Part 21 (PAR)

PART 21 REPORT FOR POTENTIAL SAFETY HAZARD ON SPEED SWITCH INSTALLED ON EMERGENCY DIESEL GENERATOR (EDG)

**FM Notification Report Serial Number 10-05
Fairbanks Morse Engine
10CFR 21.21 (d)(3)(ii) Notification**

Figure 1

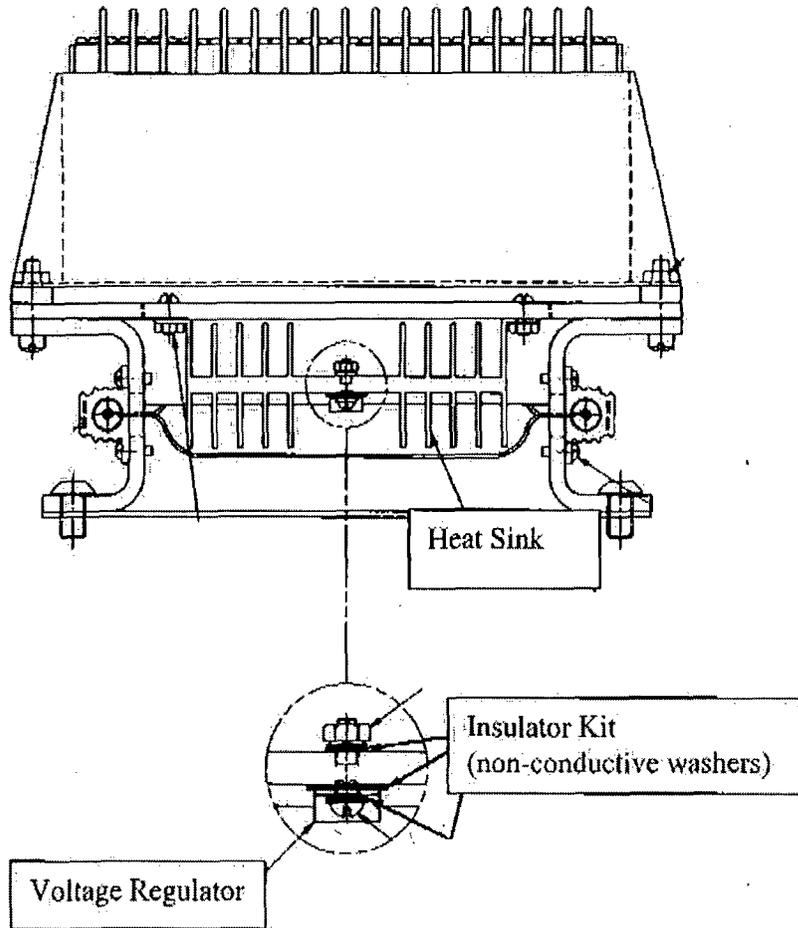
The one affected unit 11916260 created from P12620666 rev 0 was recalled and modified by adding an insulator kit (item 23) between the voltage regulator (item 8) and the heat sink (item 7) as shown in Figure 1. The design records have been updated accordingly. The assembly drawing, P12620666, and engineering bill of material have been updated. In addition the inspection plans for this part have been updated to include a circuit isolation check to confirm that the case of the voltage regulator is electrically isolated from the aluminum brackets. The inspectors have been trained in how to perform these checks.

By adding an insulator kit, the speed switch circuit was isolated from ground and verified as functional. The FM initial design of the speed switch did not include the insulator kit (non-conductive washers) that would electrically isolate the voltage regulator from the heat sink and thus the metal mounting surface.
